Our ref: 100148-PEF-ZZ-XX-RP-YE-000400
Planning Ref: BN/11/22/OUT
EA Ref: HA/2022/123981/01-L01

BARNHAM EASTERGATE WESTERGATE – RESPONSE TO ENVIRONMENT AGENCY’S HOLDING OBJECTION IN RELATION TO FLOOD RISK ISSUES

Project Name:
Barnham Eastergate Westergate

Drawing Title:
WATER DEPTH BASELINE
1% AEP + 35% CLIMATE
CHANGE

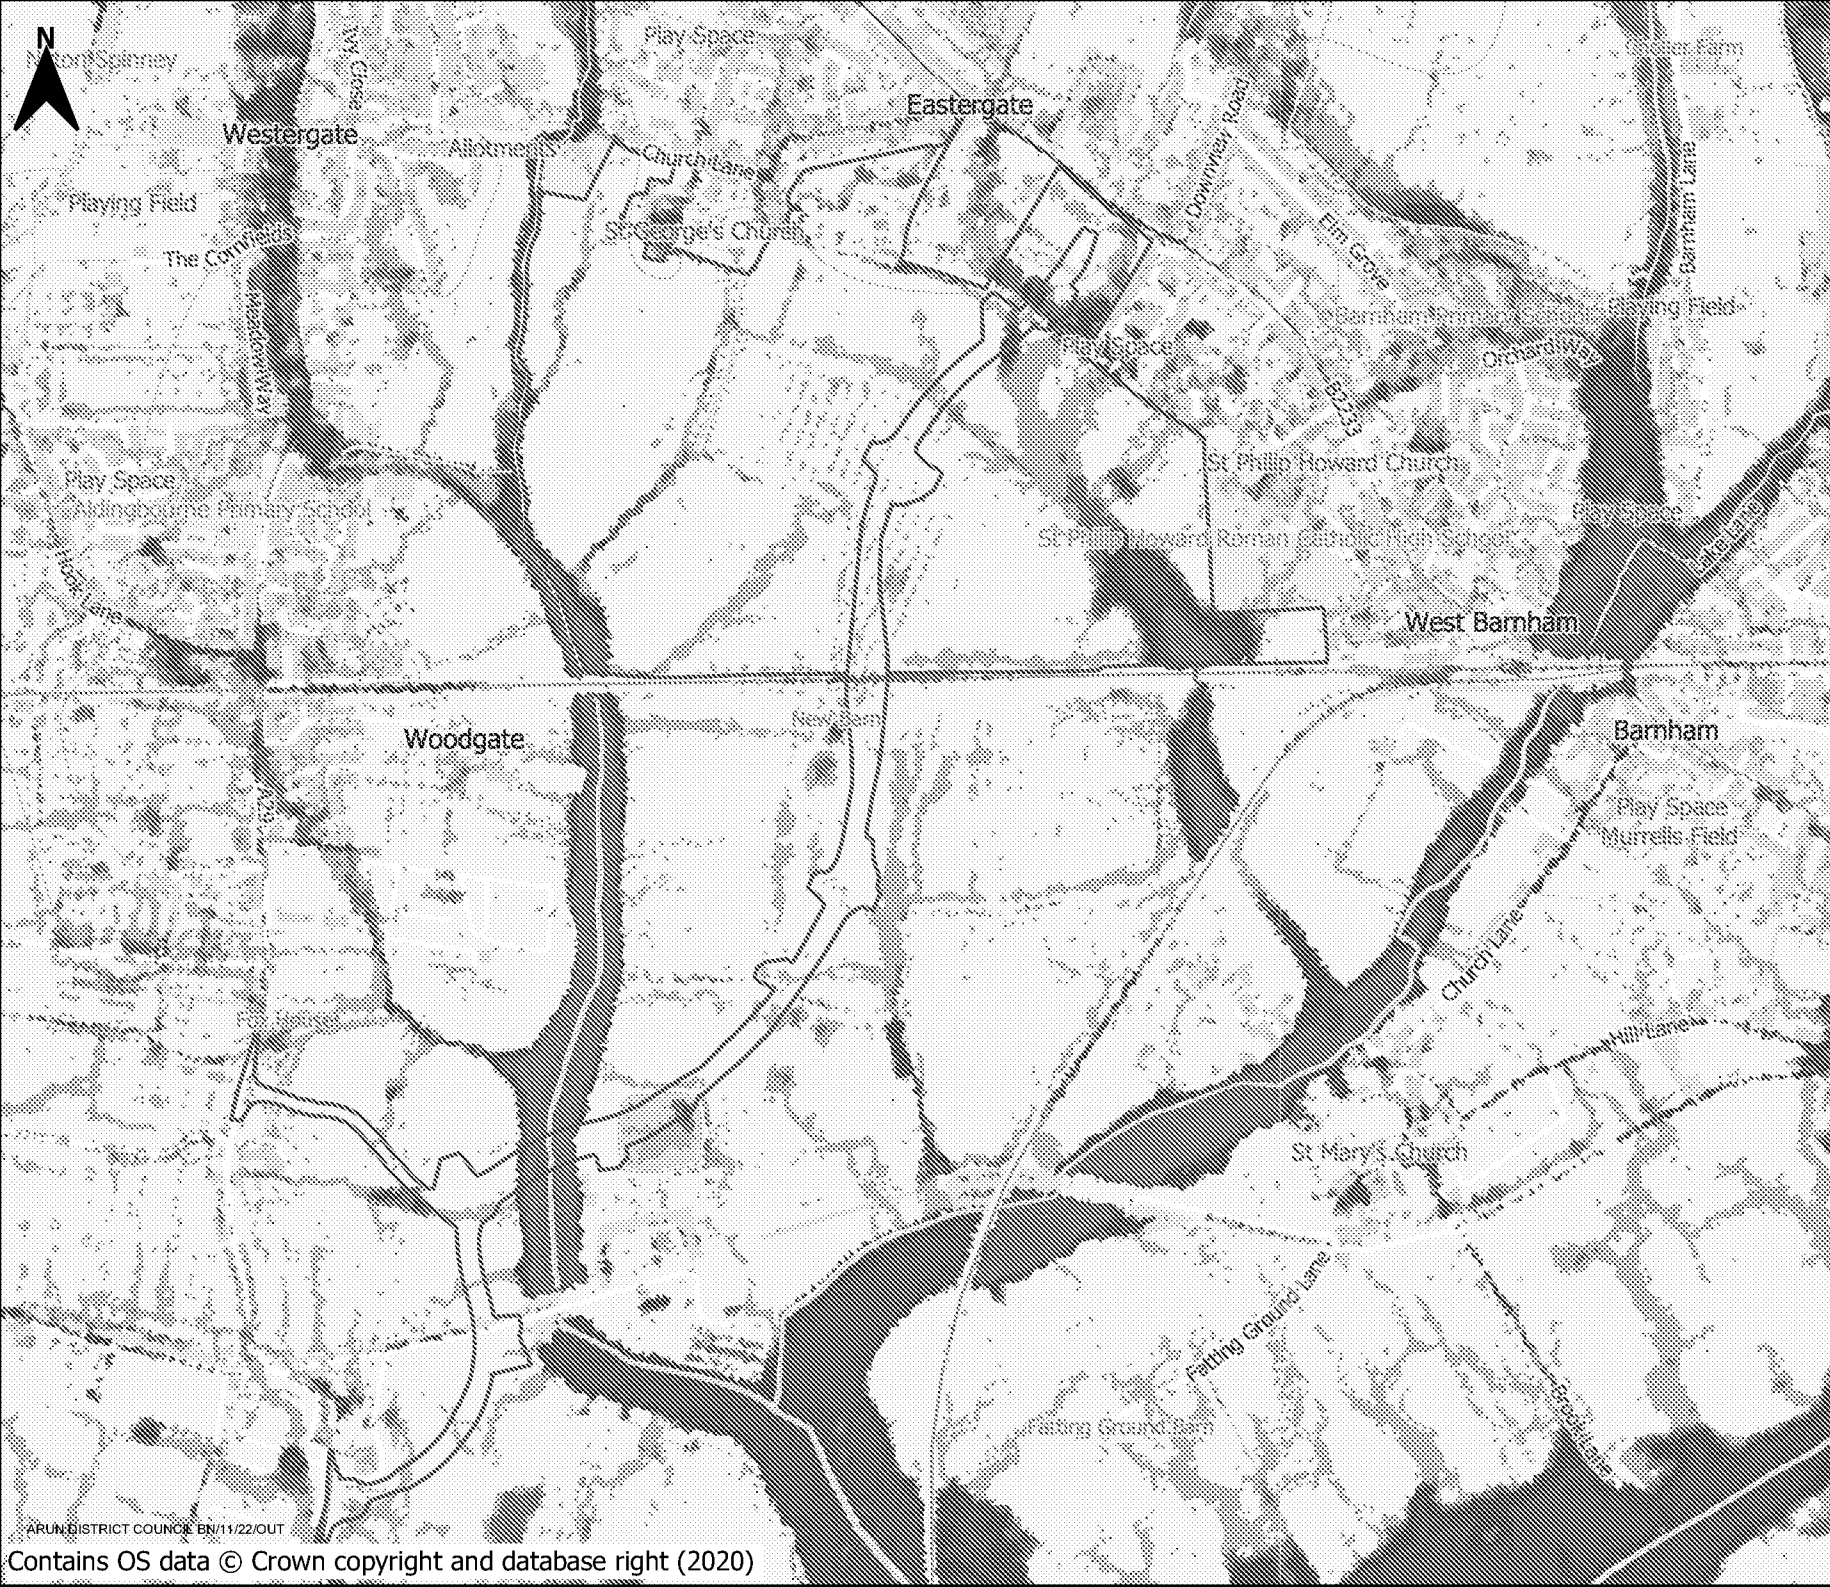
The EA’s response states that “...we would need to see reference to the latest Climate Change allowances...and their potential impact on the 200m multi-span Lidsey Rife Bridge option at multiple points.”

In response to the Environment Agency's comment, the analysis has been revised to take into account the latest climate change allowances, which suggests for such schemes the higher central allowance should be used. For the Arun and Western Streams management catchment this equates to a 36% increase in peak river flows to the 1% annual probability design event. The Environment Agency model included hydrology for the 35% increase event, which has been used to assess the proposals in line with these updated allowances. Results are appended to this letter for reference.

This demonstrates that with the bridge embankments in place, there is a minor increase in peak flood depth within the corresponding flood cell, which extends from the railway to the north to the canal towpath to the south (see drawing A11394-PEF-ZZ-XX-SK-YE-0804). These increases are in the order of 0.03m (30mm) within an area flooding to an average depth of 1.0-1.5m (see drawing A13394-PEF-ZZ-XX-SK-YE-0802), which in the context of the proposals is not considered a significant change to the floodplain.
